Access Compliance Report Public Rights-of-Way (Pedestrian Signals)

Main Street: CARBON_CANYON_RD Cross Street: VALENCIA_AVE Location: SE

ADA ID: SGAT210920110130 Signal Type: One Push Button-APS Overall Compliance: No Severity Scores: BTN 1: 25 BTN 2: N/A No BTN: N/A

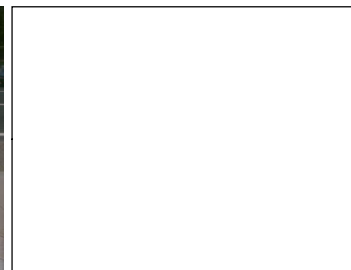
Compliance	Description	Data	Compliance	Description	Data
Button Count	Button1	No	Distant to Additional Button (in)	108	
Additional Button Present?	Yes	N/A	Additional Button ID	SGAT210920110410	
Located In An Island/Median?	Yes				
N/A B 1 Sign Present?	Yes	N/A	B 2 Sign Present?	N/A	
Yes B 1 Sign Purpose?	Yes	N/A	B 2 Sign Purpose?	N/A	
Yes B 1 Sign Lettering & Contrast?	Yes	N/A	B 2 Sign Lettering & Contrast?	N/A	
Yes B 1 Parallel To XWalk?	Yes	N/A	B 2 Parallel To XWalk?	N/A	
N/A B 1 PAR to Button?	N/A	N/A	B 2 PAR to Button?	N/A	
N/A B 1 PAR to XWalk?	N/A	N/A	B 2 PAR to XWalk?	N/A	
Yes B 1 Clear Floor Space?	Yes	N/A	B 2 Clear Floor Space?	N/A	
N/A B 1 FWD Approach?	N/A	N/A	B 2 FWD Approach?	N/A	
N/A B 1 FWD Approach Constrained?	N/A	N/A	B 2 FWD Approach Constrained?	N/A	
N/A B 1 FWD Approach Reach (in)	N/A	N/A	B 2 FWD Approach Reach (in)	N/A	
N/A B 1 FWD Approach Width (in)	N/A	N/A	B 2 FWD Approach Width (in)	N/A

Possible Solutions: Replace Signal Push Button With APS Button. Remove & Relocate Sign.
